## ADDENDUM NO: 002

**PROJECT NAME:** BSA GI Lab Renovation

**PROJECT NO.:** 43007.24

**DATE:** September 22, 2025

Cover Sheet &  
Sheet Index  
G-001

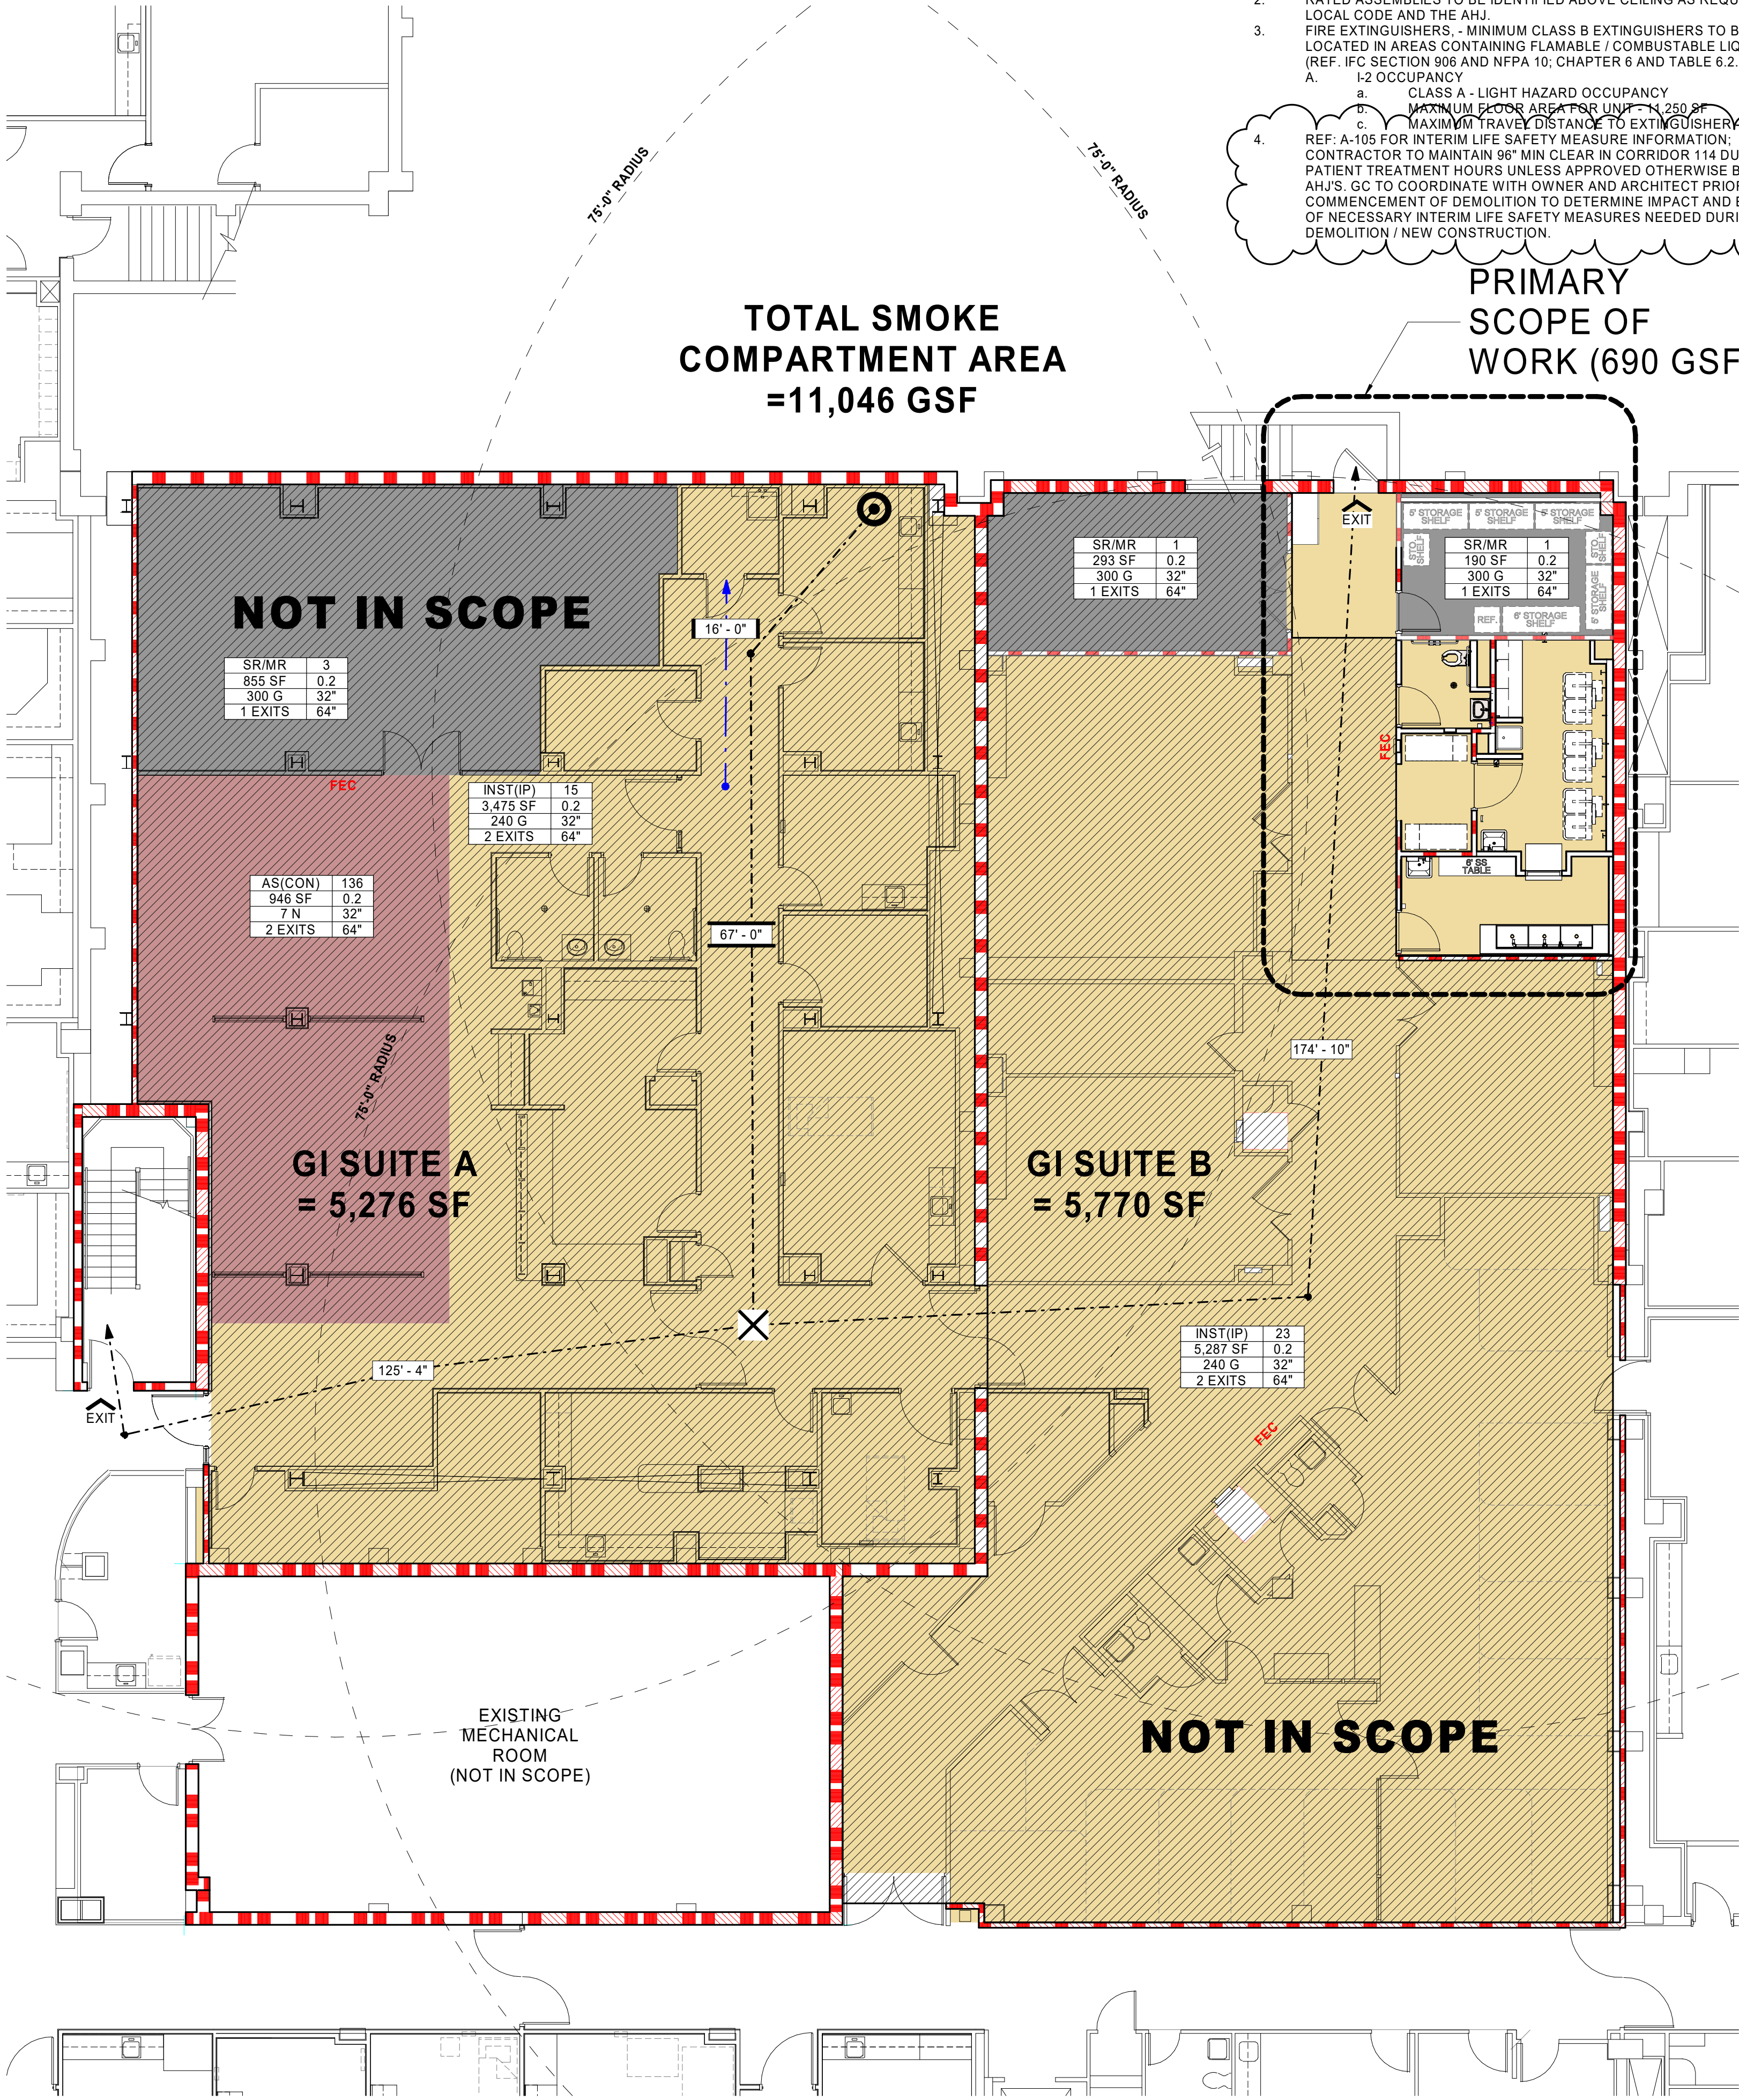
1. SHEET G-001 – Cover Sheet and Sheet Index
  - a. REVISE to update Sheet Index to include previously missing sheet A-800 per 9/15 bid walk discussion.

Life Safety  
Information

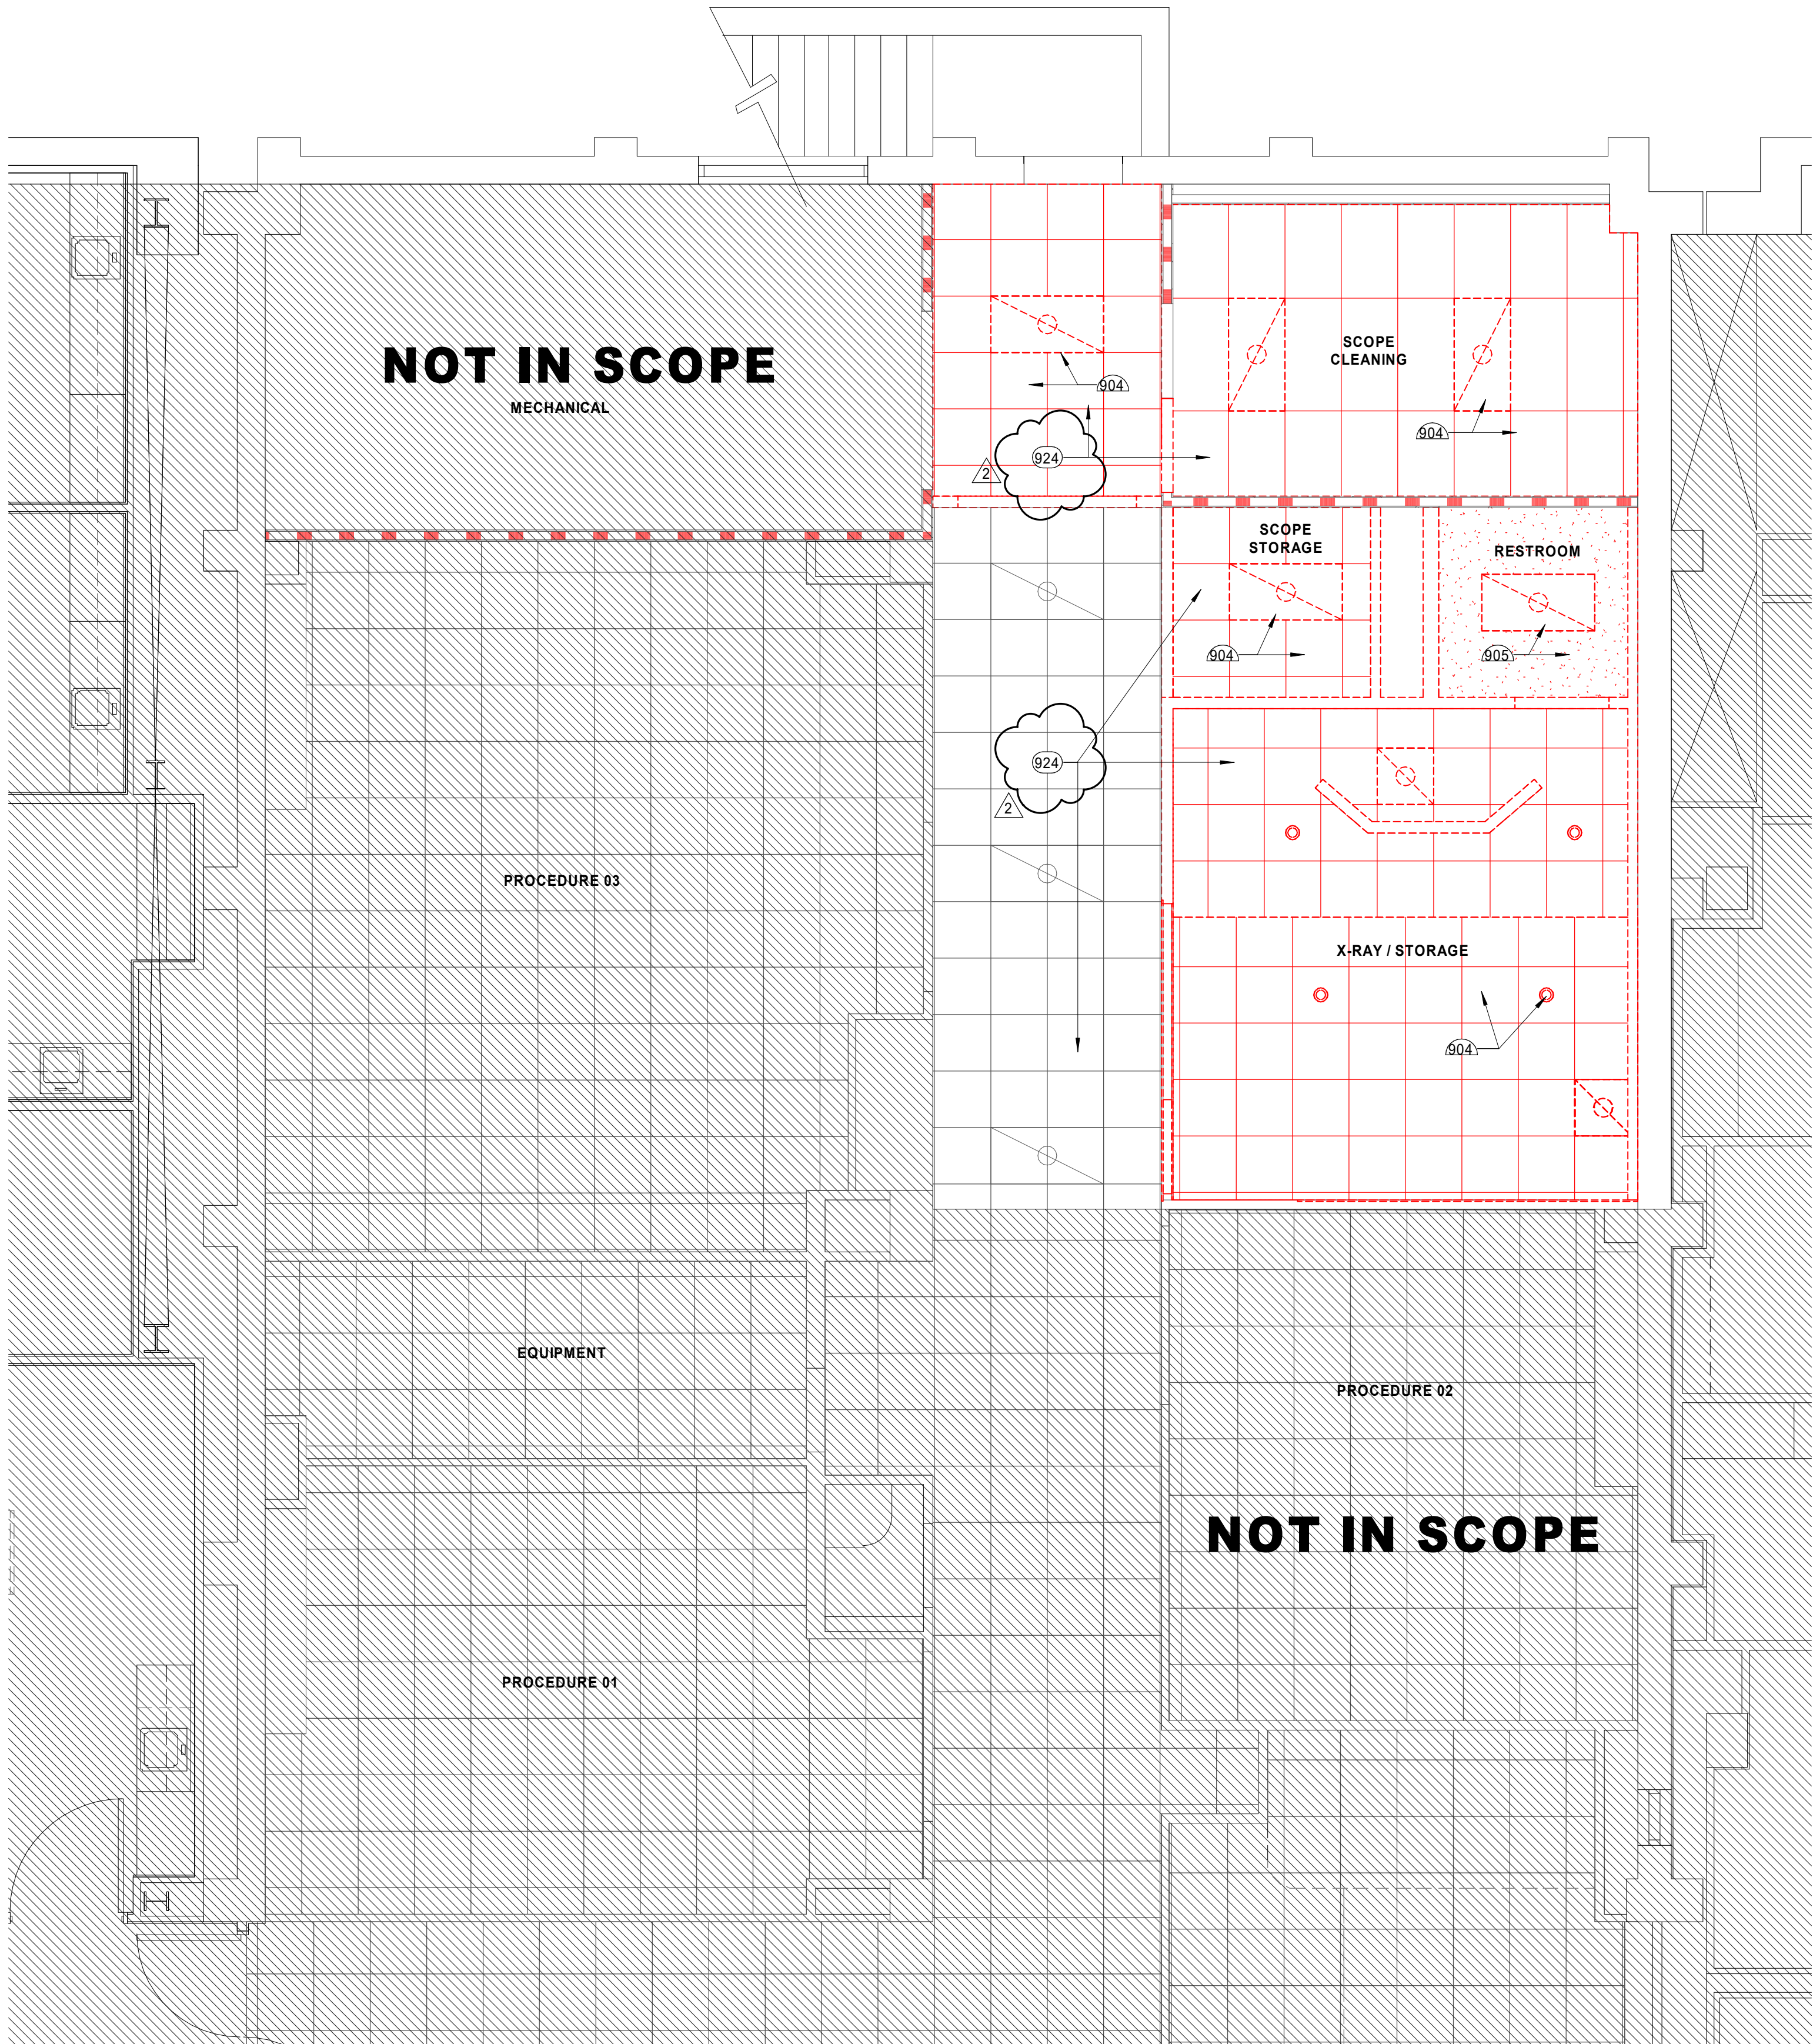
2. SHEET G-101 – Life Safety Information
  - a. REVISE to Include verbiage regarding Interim Life Safety Measures per TDH feasibility discussion on 9/18 – See A-105.

- REF: A-105 FOR INTERIM LIFE SAFETY MEASURE INFORMATION.

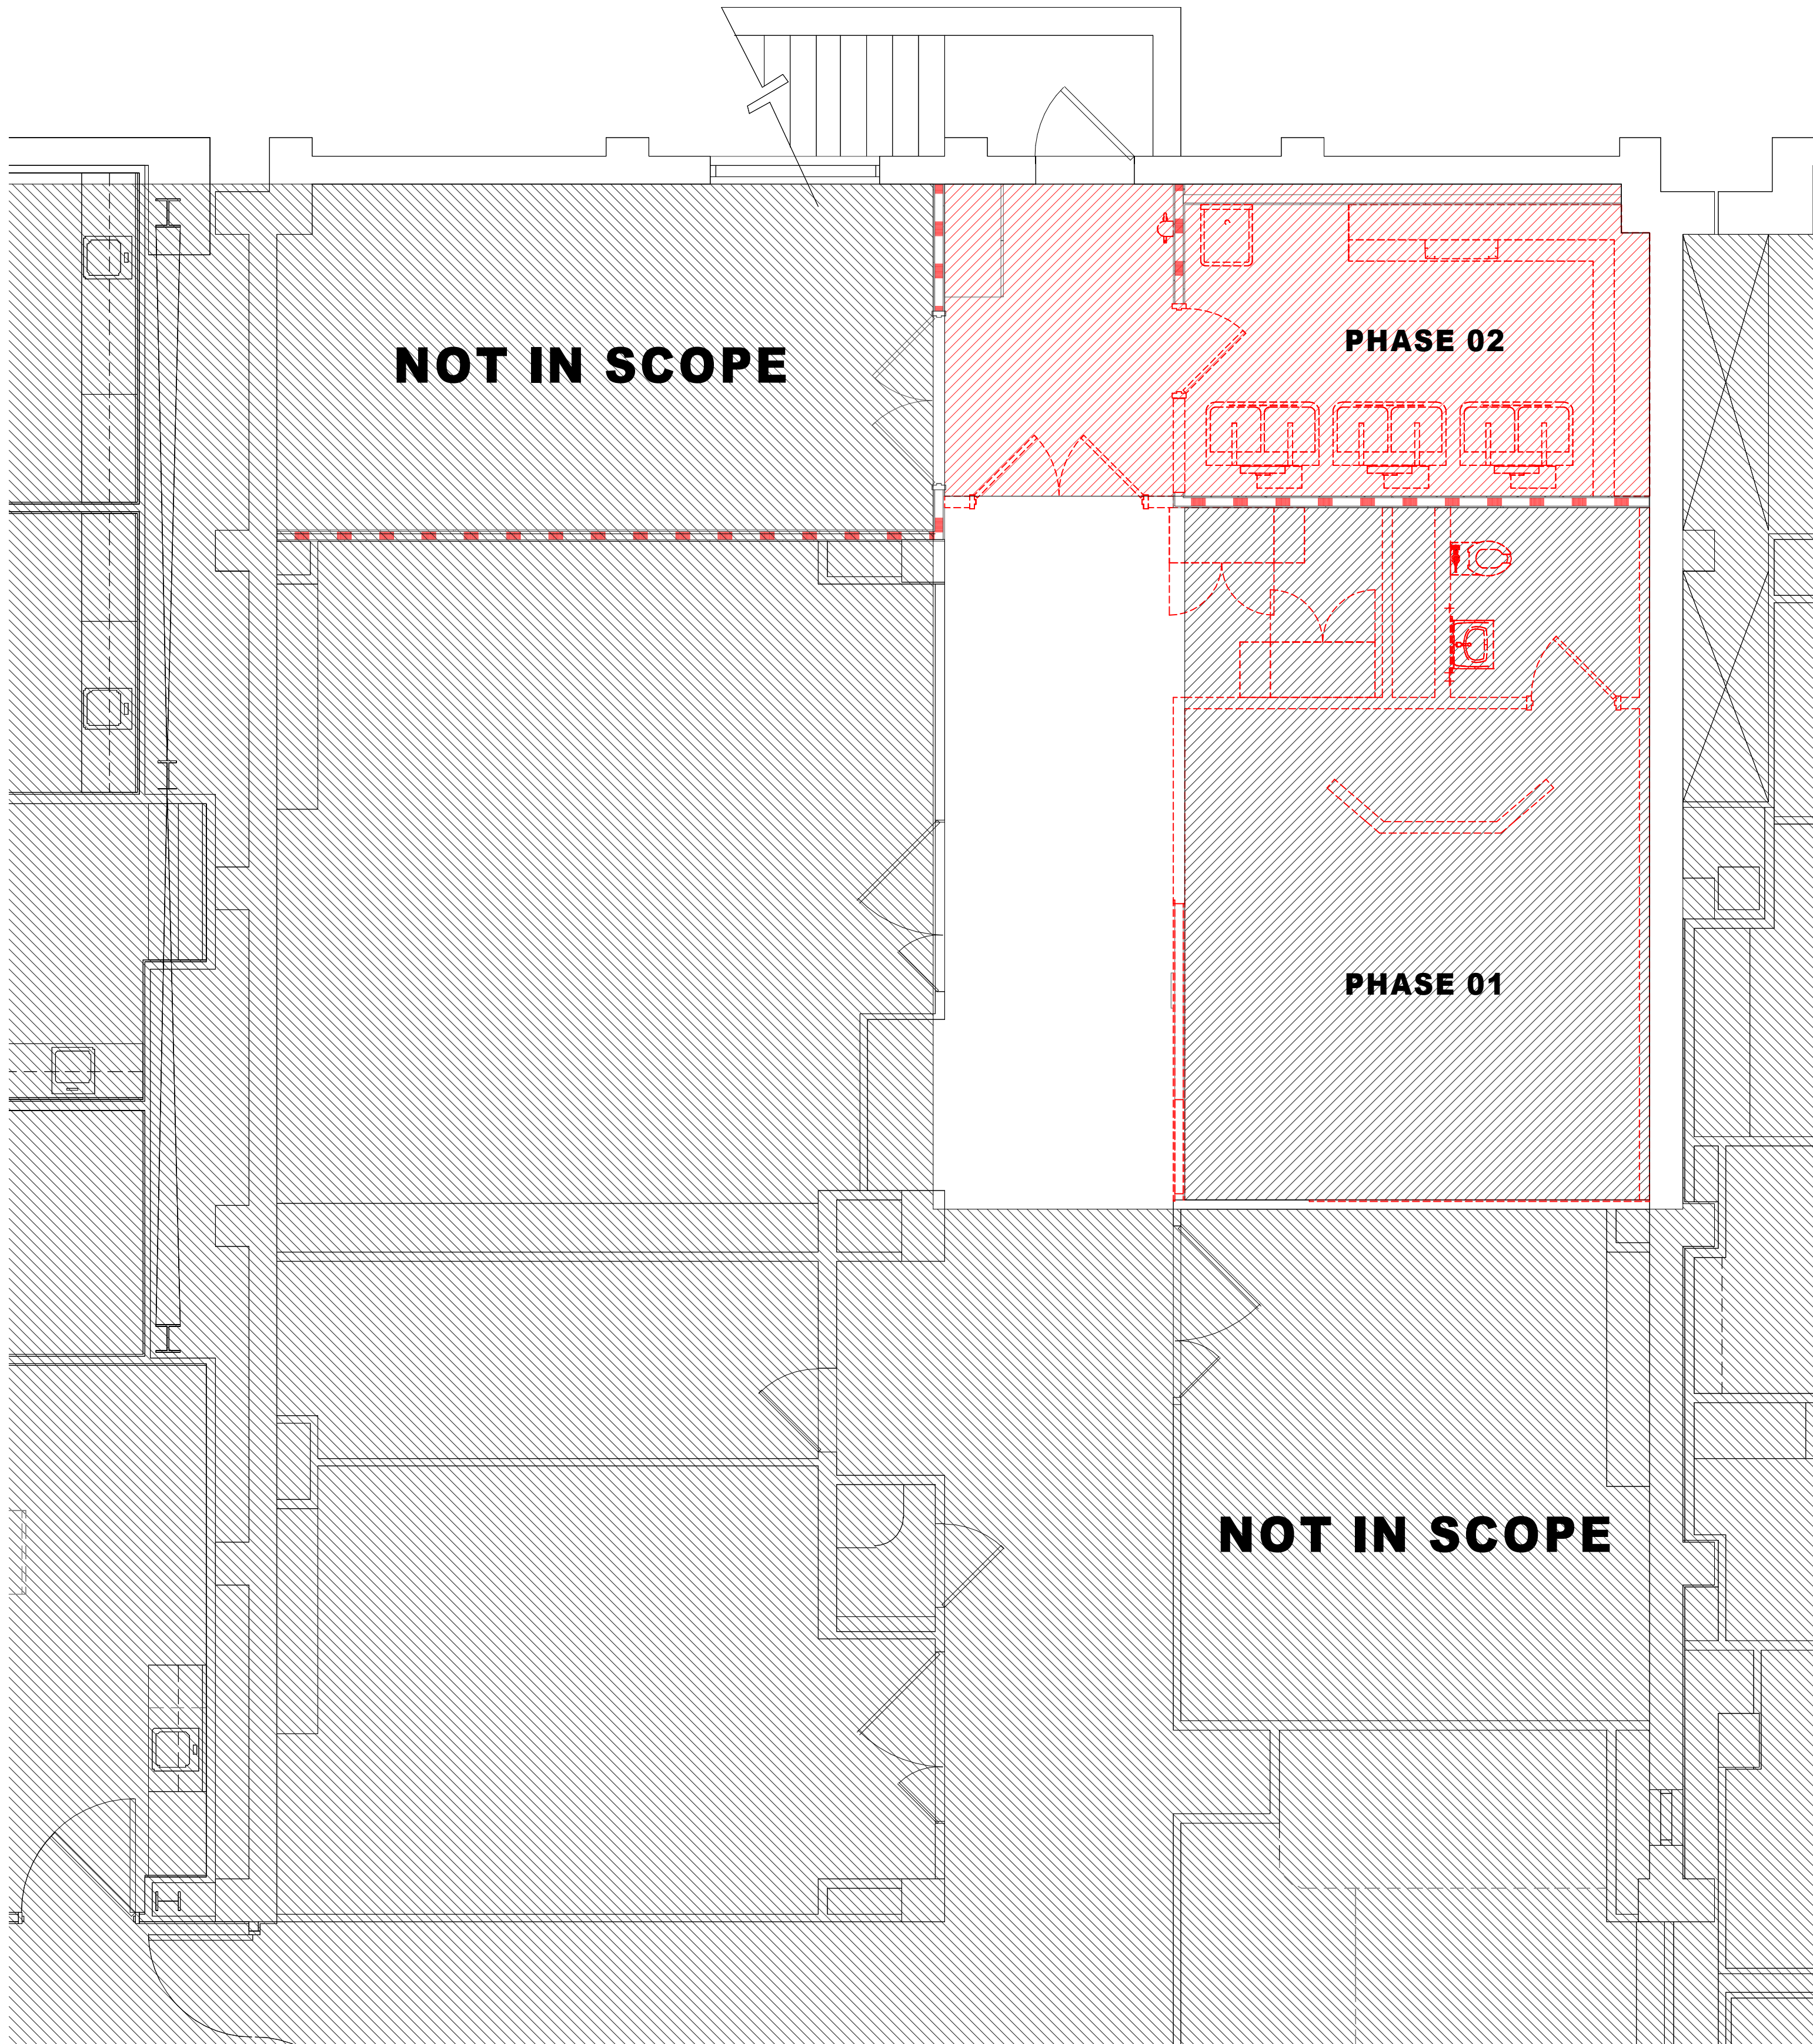
3. SHEET A-102 – Demolition Reflected Ceiling Plan
  - a. REVISE to add keynote 924 indicating the suspected presence of asbestos containing materials (ACM) within above ceiling fireproofing.

- AS INDICATED BY: /#
- 904 LAY-IN CEILING & LIGHTING TO BE REMOVED - REF. ELECTRICAL
  - 905 CEILING & LIGHTING TO BE REMOVED - REF. ELECTRICAL
  - 924 EXISTING FLOOR DECK FIREPROOFING ABOVE TO BE REMOVED AND REPLACED. TESTING INDICATES LIKELY ASBESTOS CONTAINING MATERIAL (ACM); GO TO COORDINATE WITH OWNER AND ARCHITECT PRIOR TO COMMENCEMENT OF DEMOLITION.
